JUDAH OIL, LLC

**Cedar Lake Salt Water Disposal Project
Sections 28 and 29 T17S-R31E, Eddy Co. NM**

Date : December 2011

VSW2 E&P, LLC

Figure 2: Correlations Canyon, Cisco and Wolfcamp Formations

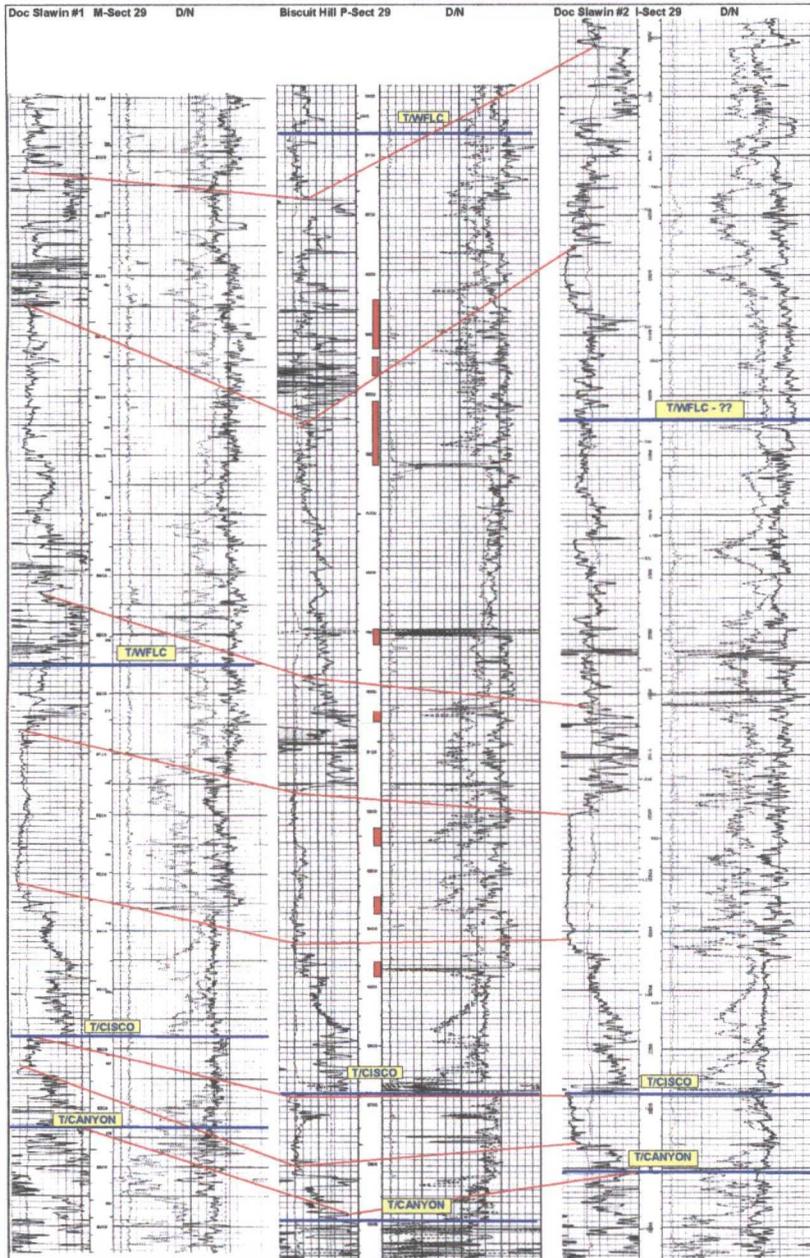
Figure 2, (x-sect Doc 1-Biscuit Hill-Doc 2), shows the top of the Wolfcamp is elusive to pick and within the review area it ranges from 8000 to 9000 feet. (Although, not technically studied, the Wolfcamp tops appear to be dependent on the geologist selecting the top and not on paleontology or faulting.) The Canyon and Cisco formations are easily correlated across the entire area as seen in **Figure 2**. (Note that the **red correlation lines** on figure 2 are drawn from gamma-ray to gamma-ray and not wellbore-to-wellbore.) Based on the major red gamma-ray correlation sections, the top of the Wolfcamp has been selected at three totally different stratigraphic events as compared to the Cisco and Canyon which are consistent.

In the Doc Slawin Fed No. 2 (Doc 2) IIC's C-108 SWD Application, it was proposed to inject into the Wolfcamp interval from 8160-9440 feet. As shown in **Figure 2**, at the time the original application was made, it was recognized that the Wolfcamp top in the Biscuit Hill (Tracey 29) was stratigraphically, significantly higher (8083 ft) than the questionable top picked by Brian Arrant, OCD (ref **Table 1**) at 8544 (???) feet and that water was being injecting into the higher stratigraphic section. Judah had George Scott III (GS), Petroleum Geologist, who has previously provided expert testimony in various NMOCD hearings (in Santa Fe), reviewed the Doc 2 and other wells in the area and he concluded that picking the top of the Wolfcamp in the absence of paleontology analysis was very difficult and subjective (he observes that this formation top varies regionally due to in part to a regional unconformity). As a result of the variations in stratigraphic picks of the Wolfcamp formation top, Judah is confining the injection interval from 8740 feet (approximately 200 feet below the 8544 feet top) to 9440 feet.

Figure 4: Doc Slawin Fed No 2 Density/Neutron and Lateral Logs

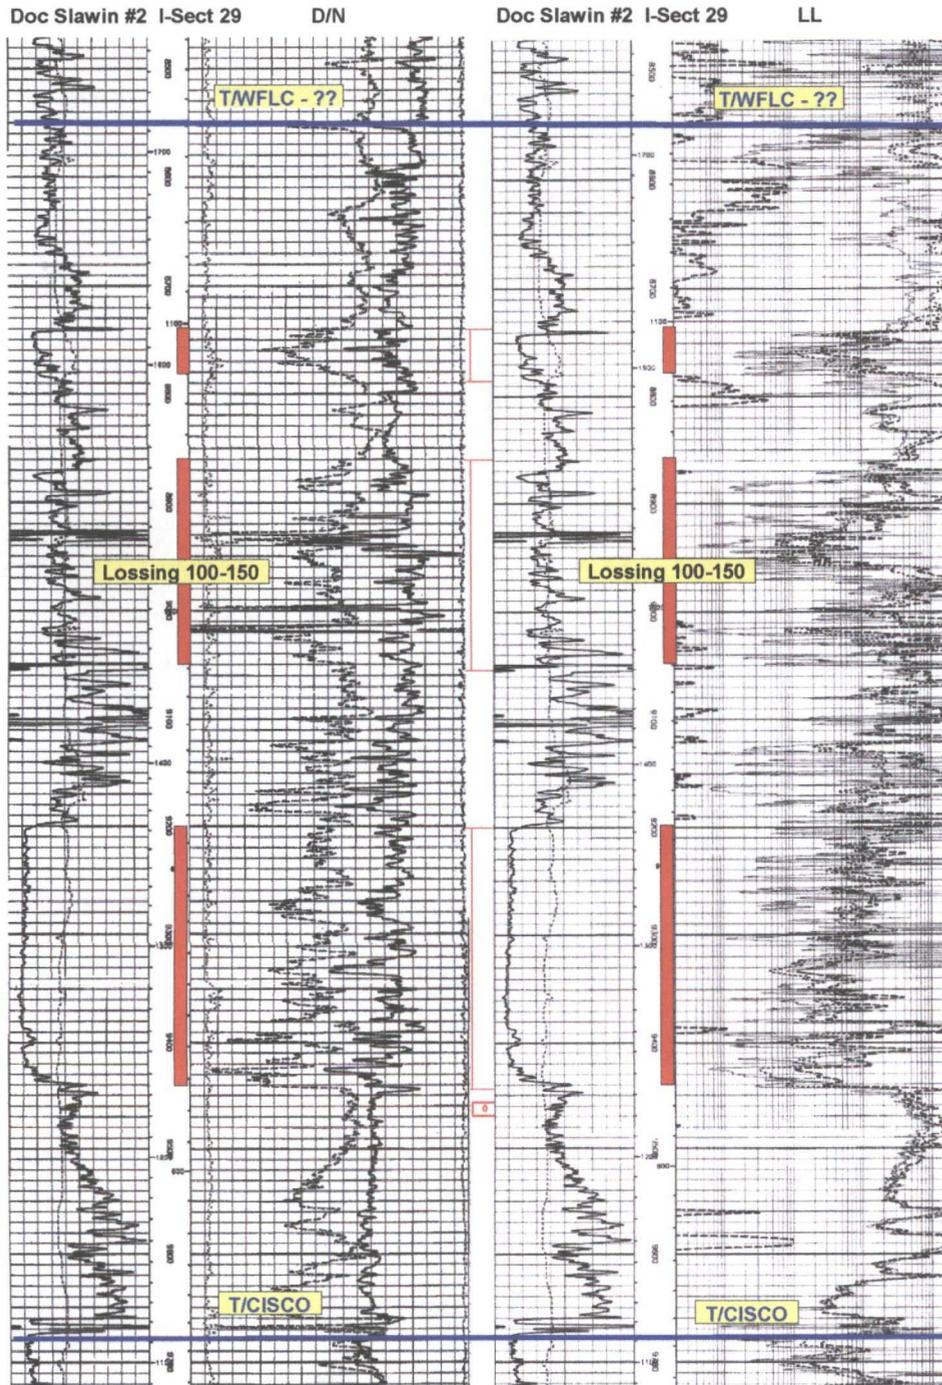
The Doc 2 injection interval from 8740-9440 feet (ref. **Figure 4**) Density/Neutron and Lateral Log) and surrounding wells were reviewed by GS for production potential.

Figure 5: Doc Slawin No 2 Mud Log

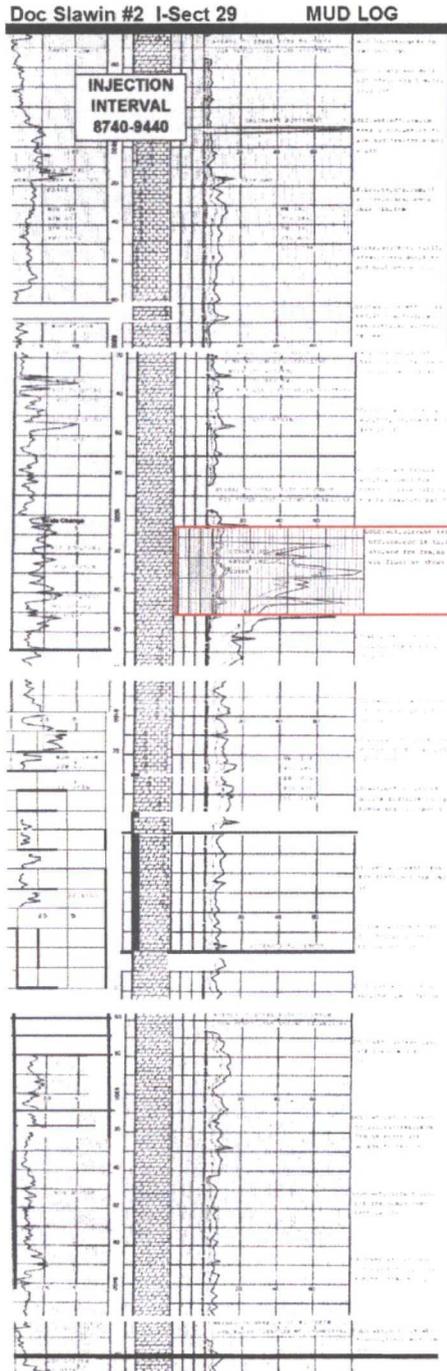
The Doc 2 Mud Log over the injection interval (ref. **Figure 5**) was reviewed. There was only one very minor gas show from 8920-8960 feet that averaged 50 total Gas Units. It had a sulfur water smell and didn't have any fluorescence or shows. GS ran log analysis to determine water saturation values over the proposed disposal interval 8740-9440 feet in the Wolfcamp formation.

Figure 8: Borehole Sonic Log Correlation SKU 161 and Dow B

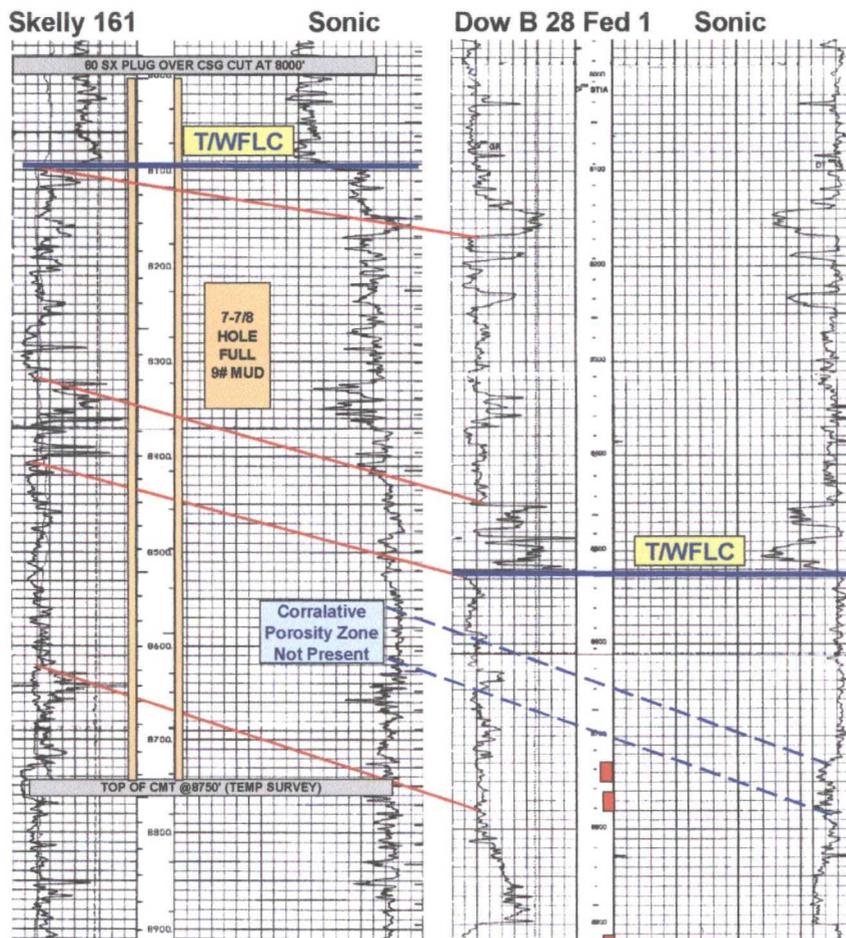
As discussed in the next section and shown in **Figure 8**, there is concern that the injection perforations in the Dow B may impact the correlative interval in the abandoned Skelly Unit Well 161 (SKU 161); which doesn't have cement behind pipe over this interval. (Note: for correlation, the red correlation lines on figure 8 are drawn from gamma-ray to gamma-ray.)

Also, as shown in **Figure 8**, GS correlated (**dashed blue lines**) the proposed porosity interval to be perforated in the Dow B with the adjacent, permanently abandoned SKU 161 Well (K-28-T17S-R31E). As shown on the figure, the porosity interval in the Dow B pinches-out and is not present in the SKU 161 Well. It was further noted that the major stratigraphic sections (**correlated by the red lines**) are very definitive, but the top of the Wolfcamp in the two wells were picked (**solid straight blue lines**) differently, further emphasizing that picking the top of Wolfcamp is very subjective in this area.

Figure 9: Correlation Wells Skelly Unit Well 161 and Dow "B" 28-1

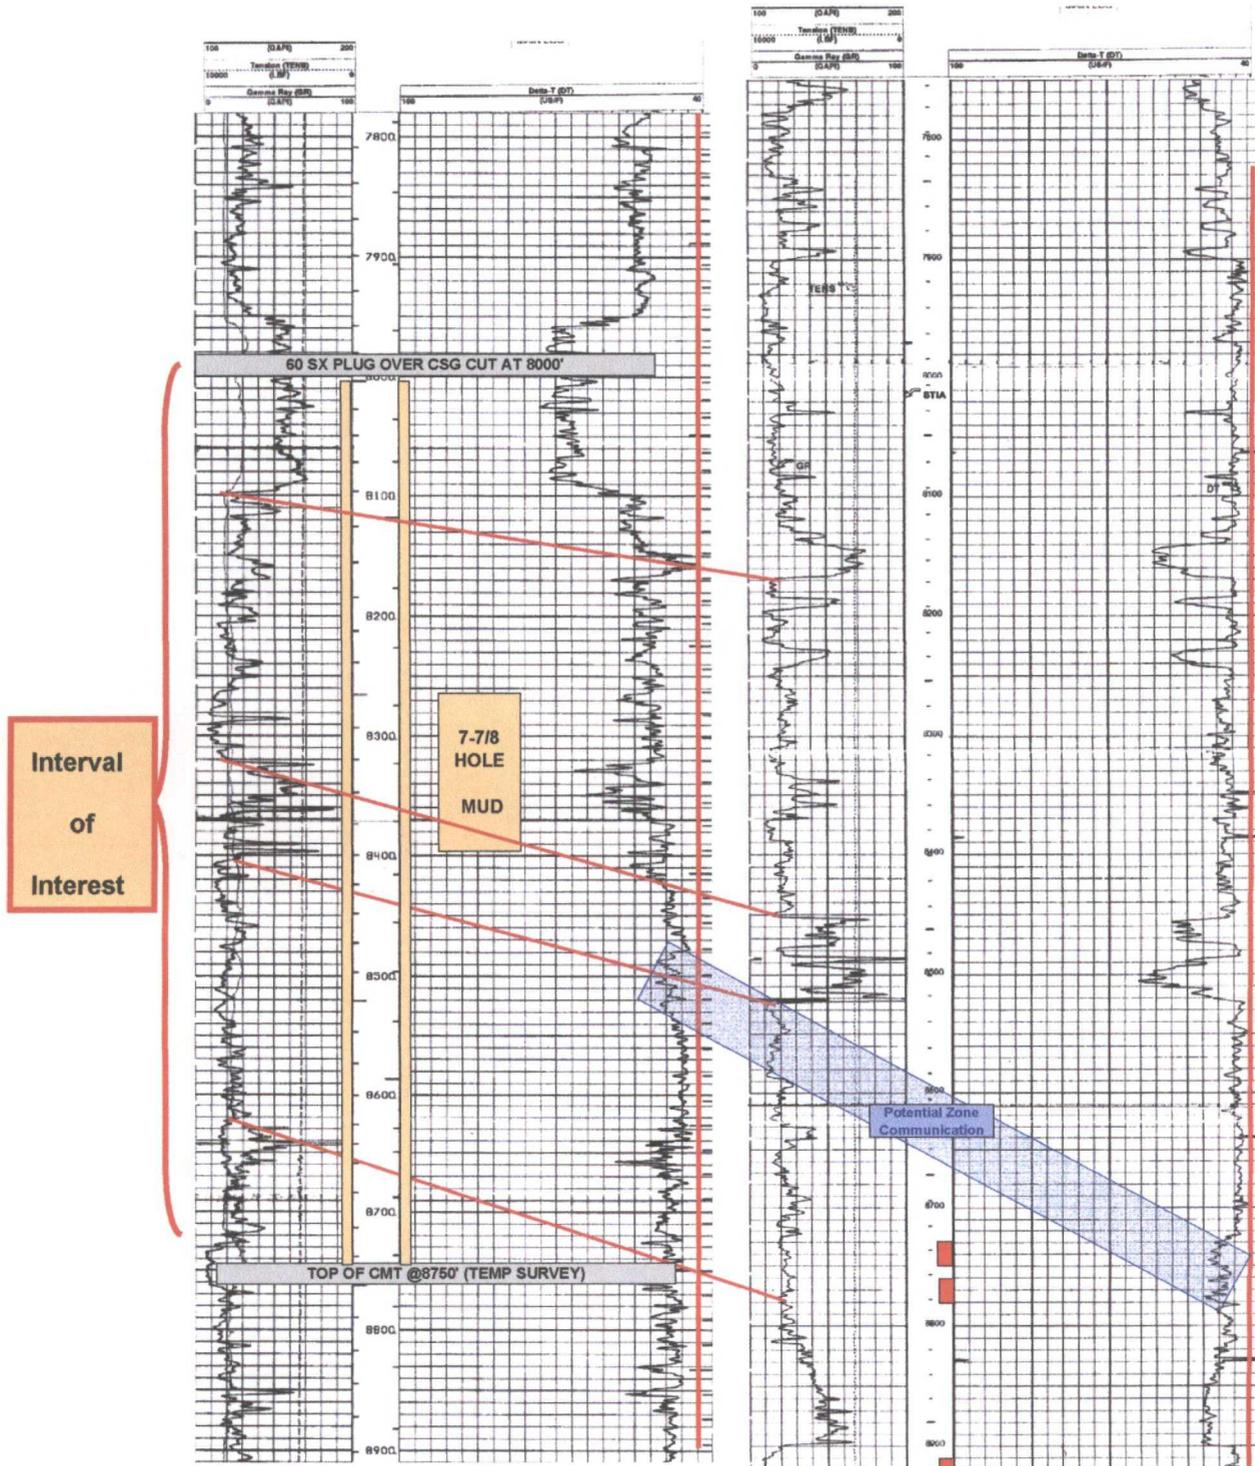
As discussed in the previous section, it doesn't appear that the upper 40 feet of proposed perforations the in the Dow B from 8730' to 8750' and from 8760' to 8780' are present in the SKU 161 Well. However, for this analysis it is hypothetically assumed that the 8730' to 8780' porosity interval in the Dow B is equivalent to the 8480' to 8530' interval in the SKU 161 which is 250 feet above the Dow B interval. This correlation is shown in **Figure 9**. The uncemented section in SKU 161 is from 8054 ft to 8750 ft. Currently the only proposed perforations for injection in the Dow "B" 28-1 are 20 feet from 8730' to 8750' and 20 feet from 8760' to 8780'. The major injection correlation (reservoir between major shale breaks) is from 8400 ft to 8625 ft in SKU 161 and 8520 ft to 8800 ft in Dow "B" 28-1.

Figure 9 shows the only potential correlation for communication between the SKU 161 and Dow B. The reality of any adverse communication and/or interference between the wells is directly dependent on the wellbore condition in SKU 161, the reservoir characteristics between the wells and the differential injection pressure in the Dow B and SKU 161. Each of these parameters is technically addressed.

Figure 10: Current Wellbore Schematic Skelly Unit Well 161

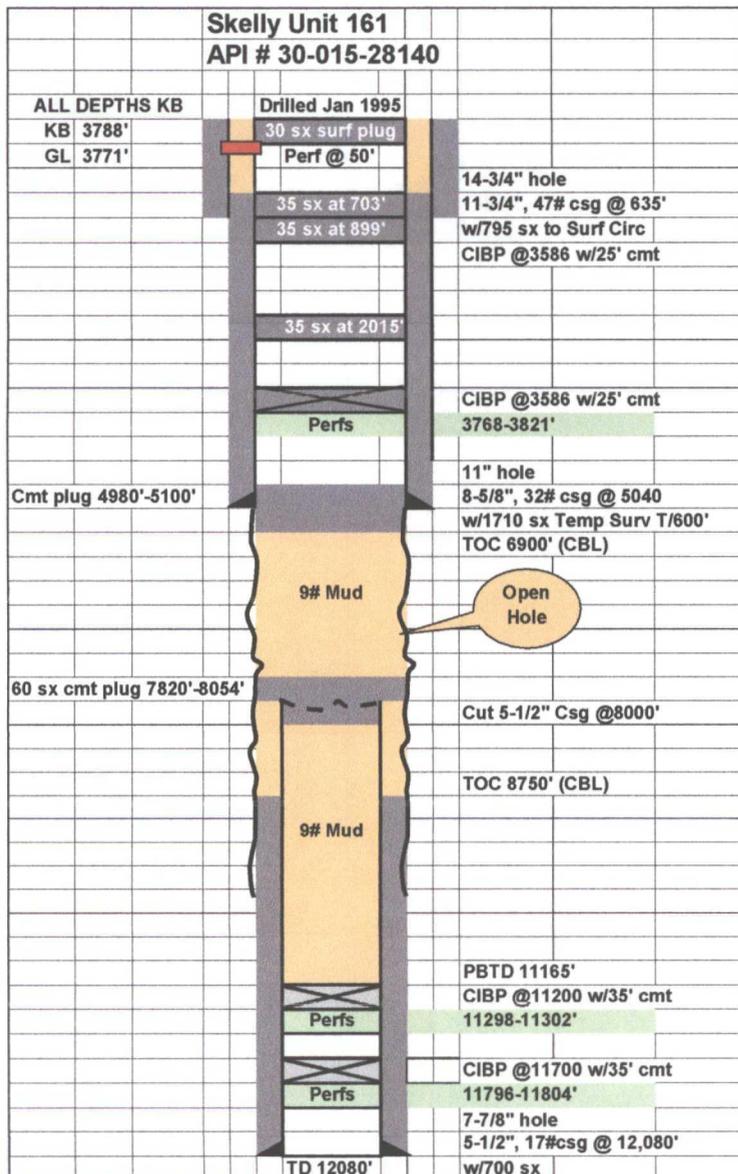
The well file on SKU 161 isn't very complete. The well was apparently drilled in January 1995 as an unsuccessful Atoka/Morrow completion. Five and one-half inch (5-1/2") casing was run to TD and cemented. The Cement Bond log shows the top of good cement at 8750 feet. After failing to complete the deep zones in 1995, the 5-1/2" casing was cut at 8000 ft. A 60 sack cement plug was set at 8054 feet and the top of the plug was tagged at 7820 ft. The result is 180 ft of cement in the open hole above the 5-1/2" casing and 54 ft of cement inside the casing. This plug should be an excellent barrier to prevent any mud or fluids from flowing up the 5-1/2" casing or the casing-hole annulus. **Figure 10** is the best representation of the final and current wellbore condition.

Based on the wellbore conditions above, the 9# drilling mud is trapped by cement in the 5-1/2" casing and the 5-1/2" open-hole annulus and is completely sealed. The records available on the two wells do not reference any unusual presence of fractures and/or intervals of very high permeability (>1 Darcy) where any fluid losses occurred. From this, it is concluded that the reservoir has normal Wolfcamp porosity and permeability (as discussed in the geological section). The #9 drilling mud sealed-off the normal, expected wellbore permeability during drilling.

Figure 11: Location Map Wells SKU 161 and Dow "B" 28-1

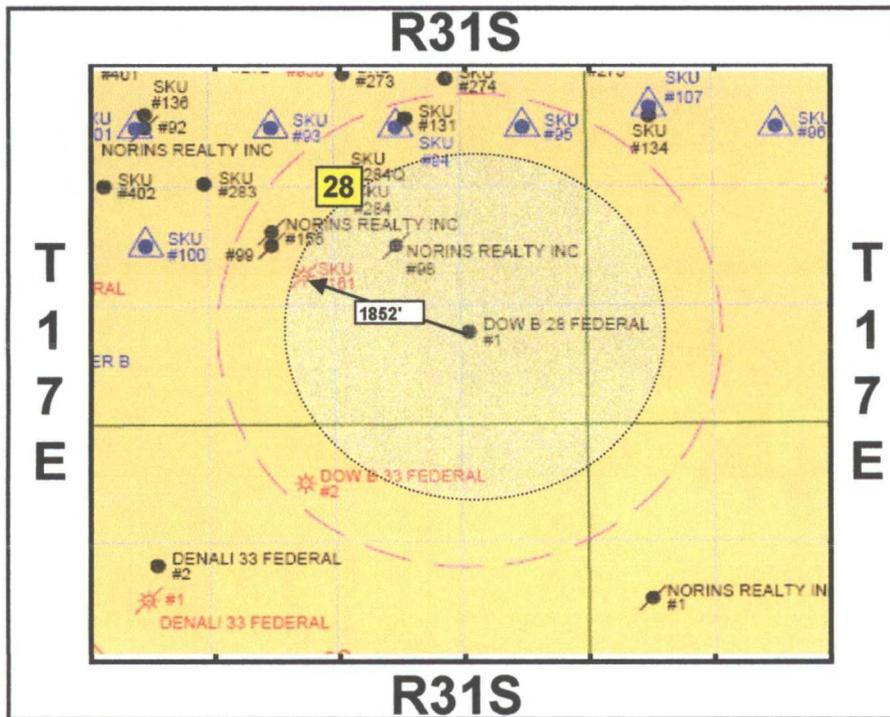
The first technical calculation is to estimate how long it will require water to reach SKU 161. Figure 11 is a map showing the distance between the wellbores to be 1852 feet.

For the following technical calculations, reasonable reservoir parameters have been assumed for the Wolfcamp in the interval of interest. As will be demonstrated, the reservoir parameters could be off by a factor of 1,000 and still not affect the conclusions drawn. The time required for water injected in the Dow "B" 28-1 to reach the SKU 161 is based on an injection of 50 BWPD into each one foot of pay open. In this example, the 40 feet of perforations will take (50 x 40) 2,000 BWPD. Using the 1852 ft radial flow area from the Dow "B" 28-1, with a porosity of 10% the reservoir fill-up volume to SKU 161 is 7,672,440 barrels. Table 2 below shows all the calculations for this analysis.
